# PREDETERMINATION SETTLEMENT AGREEMENT

CP# 10-17-71050  
HUD# 07-18-7632-8

Complainant specifically alleged, in Unit 107, 5719 NW 57<sup>th</sup> Avenue, Johnston Gardens Apartments (“Johnston Gardens”), two features in the common areas and three features within one of the covered ground-floor units appeared inaccessible to a person utilizing a wheelchair for mobility – (1) the heights of the midlines of the keyholes at the mailbox compartments assigned to Units 101 and 102 at the kiosks each of the three buildings were measured at 58” (Unit 101), and 55” (Unit 102) – all of which are higher than the 54”-maximum allowed for a parallel approach by persons using a wheelchair; (2) the height of the curb in front of the mailbox kiosks is at least 5” – which is greater than the ¼”-maximum allowed by ANSI for changes in level along accessible routes – and the loose gravel to the left and right of the kiosks – which does not meet ANSI’s requirement for a “stable, firm, and slip-resistant” surface – render the mailbox kiosks inaccessible to persons using a wheelchair; (3) the clearance from the midline of the sink to the wall in Unit 107 was measured at 21 3/16”, which is less than the

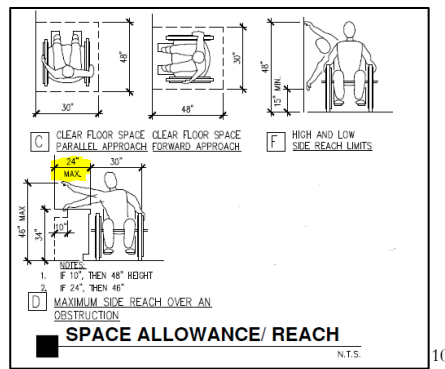
the 54"-maximum allowed for a parallel approach by ANSI 1986. However, there is a 6 1/8" high curb. This curb creates an obstruction in front of the mailbox kiosks, which has a horizontal projection to mailboxes that was measured at no less than 36". So, even without regards to their heights, the mailboxes are rendered unreachable by virtue of the 36"-depth of the obstruction, which exceeds the 24"-maximum allowed in ANSI 1986 by 12".<sup>8</sup>

Based on these instructions, the heights to the midline of the keyholes of the mailbox compartments were designed to comply with FHA requirements. Also in their plans, Respondents included instructions and diagrams about the technical requirements for reachability, which are shown below:

Based on these instructions and diagram, the distance required to reach operable fixtures, including mailboxes, was designed to be no more than 24". However, as installed, the distance required to reach the mailboxes exceeds the 24" maximum by 12". Each of these factors – the horizontal projection of the obstruction caused by the change in level in the curb and the height of the top two rows of mailboxes – render these mailboxes inaccessible to persons using wheelchairs for mobility.

- 2) ICRC concurs with Respondents’ proposal to move the mailbox kiosks to either the front of the curb adjacent to the current location or to the front of one of the buildings; and (ii) coordinate with the United States Postal Service to reassign the mailbox compartments, such that the mailboxes of all ground-floor units will be at or below the 54”-maximum height. ICRC will require that this modification be completed within 60 days of the date of the Closing Letter from ICRC.

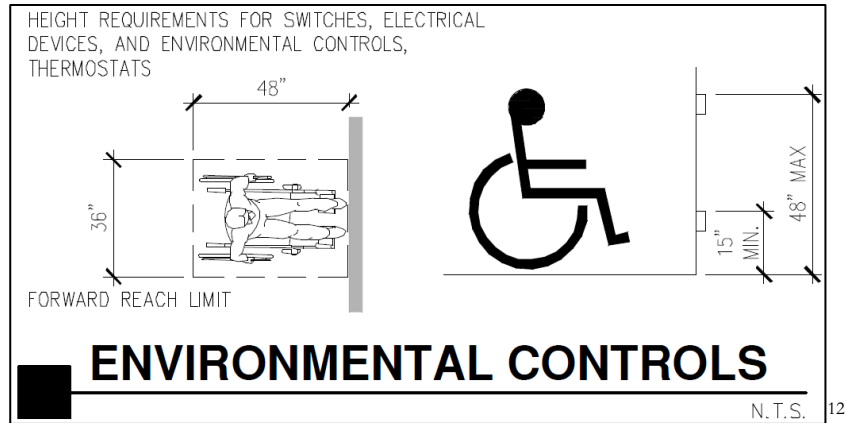
3) The height of the top control buttons of the thermostats in all inspected units was measured at 54 1/8", which exceeds the 48"-maximum height.<sup>11</sup>

The plans submitted by Respondents included the following instructions and diagrams for the installation of the thermostats:

The heights of the thermostats in these inspected units would have been compliant with the 48"-maximum height requirement as referenced above if installed according to the plans. But, as built, they are too high, rendering them unusable by persons using wheelchairs.

- 3) ICRC concurs with Respondents’ proposal to relocate the thermostats to decrease the height of the highest operable control to no more than the 48”-maximum height allowed by ANSI 1986. ICRC will require that this modification be completed within one year of the date of the Closing Letter from ICRC or sooner if requested by a tenant with a disability.

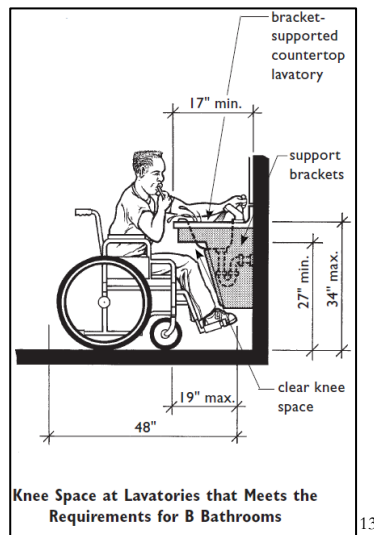
Additionally, ICRC Investigators measured the height of the bathroom sinks. In bathroom sinks with removable cabinets installed at Specification-B bathrooms, the Guidelines require the height to the top of the rim at the sink to be no more than 34", as shown below:

The height of the bathroom sinks in all inspected units was measured at no less than 36 3/4", which exceeds the 34"-maximum height allowed by the Guidelines.<sup>14</sup>

- 4) ICRC concurs with Respondents’ proposal to replace the removable vanity cabinets – which have sink rims at heights exceeding the 34”-maximum – with shorter cabinets to decrease the height of the sink rims to no more than 34”. ICRC will require that this modification be completed within one year of the date of the Closing Letter from ICRC or sooner if requested by a tenant with a disability.

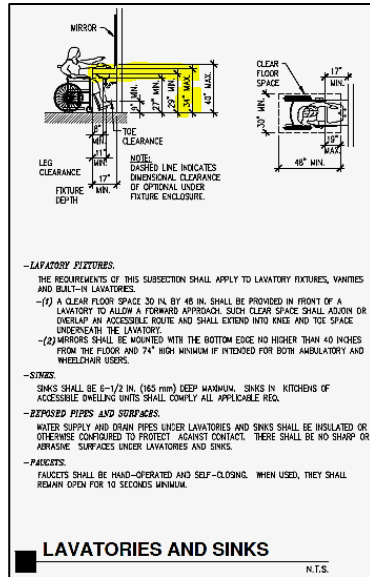
The plans submitted by Respondents included the following instructions and diagrams for the installation of the bathroom sinks:

The heights of the bathroom sinks in all inspected units would have been compliant with the 34"-maximum height requirement as referenced above if installed according to the plans. But, as built, they are too high, rendering them unusable by persons using wheelchairs.
